AGM BATTERY REPLACEMENT

Prevost vehicles

On the vehicles affected by this bulletin, replace the batteries by a new set (4) of the same model; perform several verifications on the alternator and charging circuit. Finally, update the multiplex software to the latest version and disable Alternator Management on select vehicles.

Figure 2

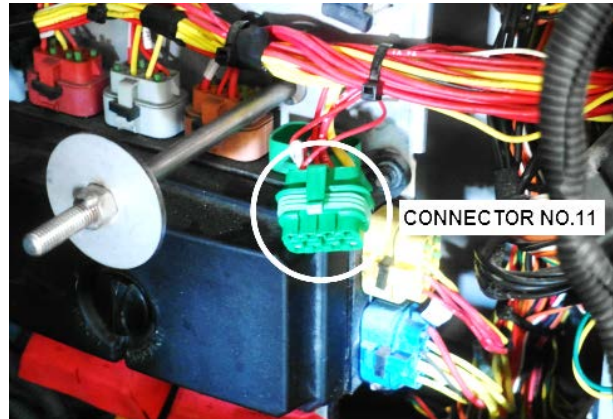
- 1.2 Unplug connector no. 11 (green).

- 1.3 Using an extractor tool or a small flat blade screwdriver, remove wire 24VDALT from cavity H of connector no.11 (Figure 2 to Figure 8).

Figure 8: 24VDALT16 wire relocation

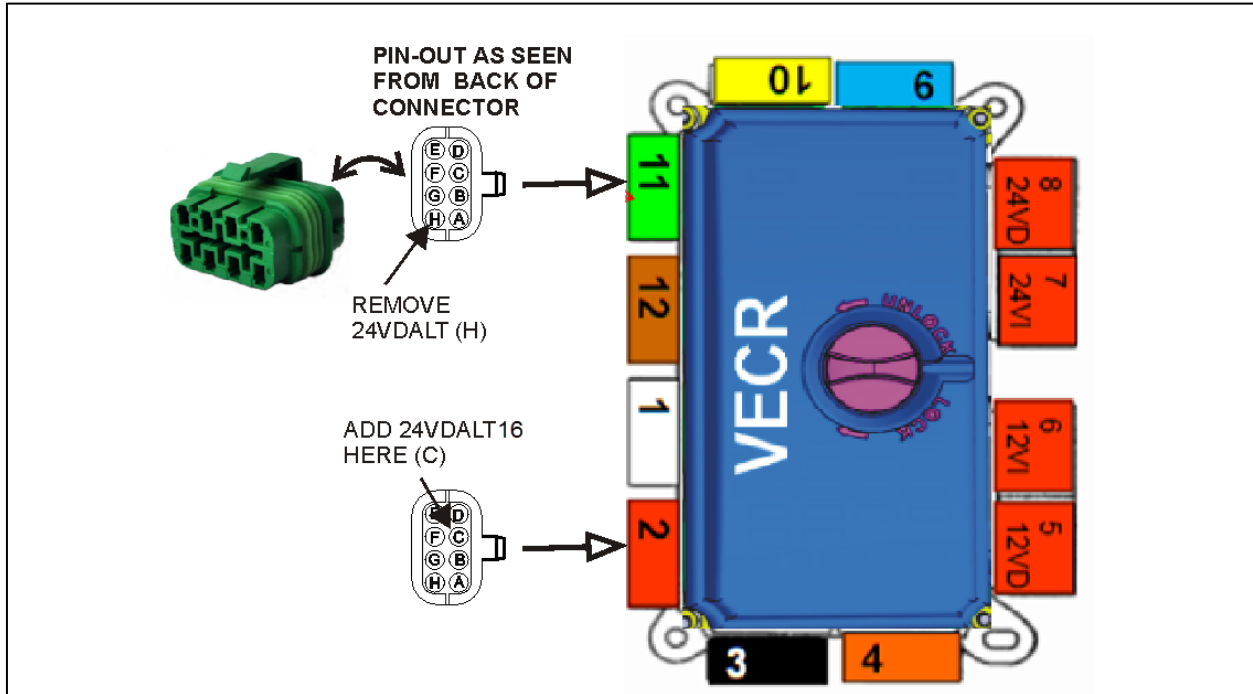
-
- 1.10 Relocate wire 24VDAULT16 to cavity **C** of connector no.2 (red) on the harness. (Figure 8)

*Cavity **C** of connector no.2 should be available. This branch of the circuit will be protected by 10A Circuit breaker CB64 (see Figure 10 below).*

*Should cavity **C** not be available, refer to your vehicle wiring diagram page 5.1 to select another free cavity protected by a 10A or 15A CB (see Figure 8 for reference).*

IMPORTANT NOTE: If required, extend wire 24VDALT16 using 16 AWG red electrical wire in order to reach connector no.2. Refer to MATERIAL section for optional parts required extend the wire.

Cut and discard existing terminal. Extend wire 24VDALT16 with heat shrinkable butt splice 563622. Place heat shrink sleeve 062490 over soldered joint. Crimp the terminal 564055 to the wire and seal 12089679 (see Figure 6).

Figure 11: BATTERY CONNECTIONS

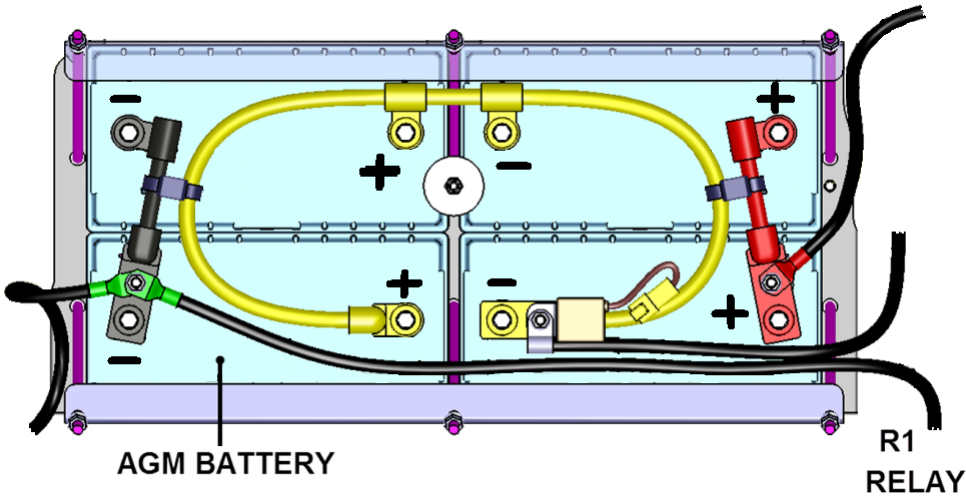
24VD battery cable to R1 main battery relay (Figure 11) is still powered after battery master switch is set at the off position.

Figure 20: CABLES RECONNECTION

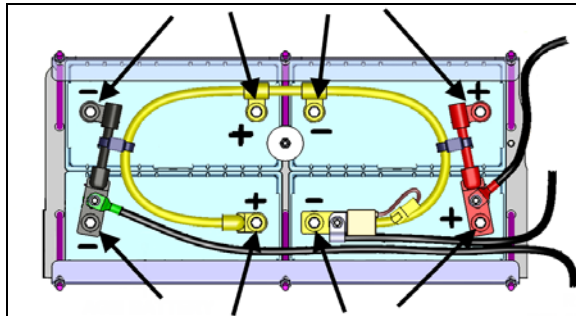
- 3.11 Lower the battery cable assembly and re-connect the (8) battery connections, the negative cables shall be the last reconnected cables.
- 3.12 Torque the battery connections to **180 lb-in** using a 14mm socket and a torque wrench. Apply torque seal mark.

Figure 22: 4/0 AND 2/0 NEGATIVE TERMINALS RECONNECTION

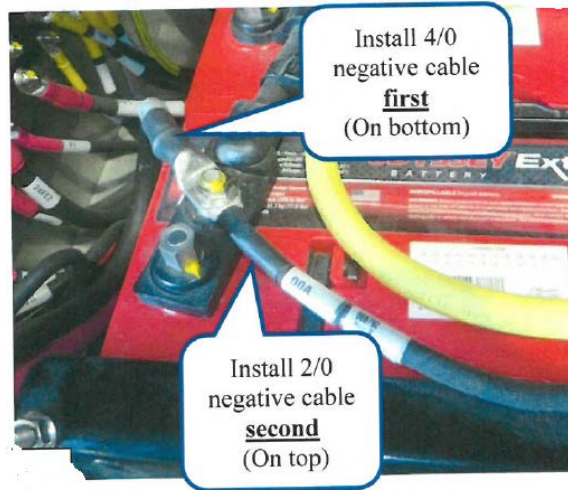
- 3.14 Torque the negative terminal nut to **170 lb-in** using a 14mm socket and a torque wrench. Apply torque seal mark.

Figure 26: A49. J1

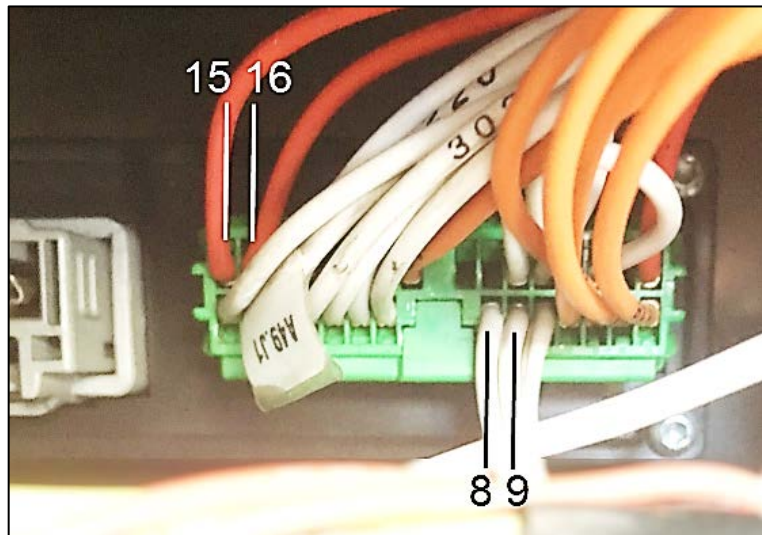
4.2 Alternator control circuit verification: Check Voltage at indicated pins of A49.J1, fill Table 1 below.

- With Key **OFF**:
All values should be around 0V
- With Key **ON**:
PIN 8 and 9 should be around 1.2 V
PIN 15 = 24V Bat.
(Figure 26)
- With **Engine running**:
All values should be above 28V.

- 4.4 With key OFF and Emergency cut out switch ON, read voltage at A49 pin 15 and pin 16. If voltage is present, this is an alternator with an internal short circuit. (Figure 26)
- 4.5 Replace shorted alternator per bulletin MI16-17E and report problem on warranty claim
- 4.6 Reinstall removed cable ties.
- 4.7 Install the electrical box protective cover (number 1, Figure 31)

Figure 30: Jumper cable ammeter clamp position

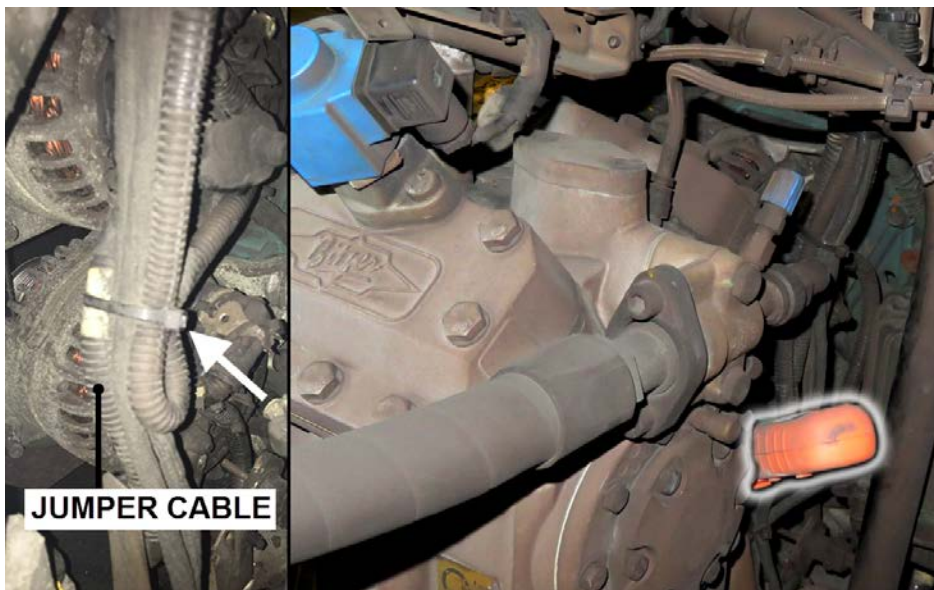
- Amperage on main alternator cable alongside the engine (Figure 29).
- Amperage at jumper cable between alternator 1 and 2 (Figure 30)

Note: Remove any additional wiring harness attached to this jumper cable by cutting cable ties. (Arrow, Figure 30) This will allow clamping only the jumper cable and getting a proper measure of amperage.

Note: One alternator may deliver more current. As long as the total load is higher than max capacity of one alternator (110 A for 120 A alternator) (140 A for 150 A alternator), if both deliver current this test is successful. If voltage drops below 28V or one alternator does not deliver current, check alternators further.
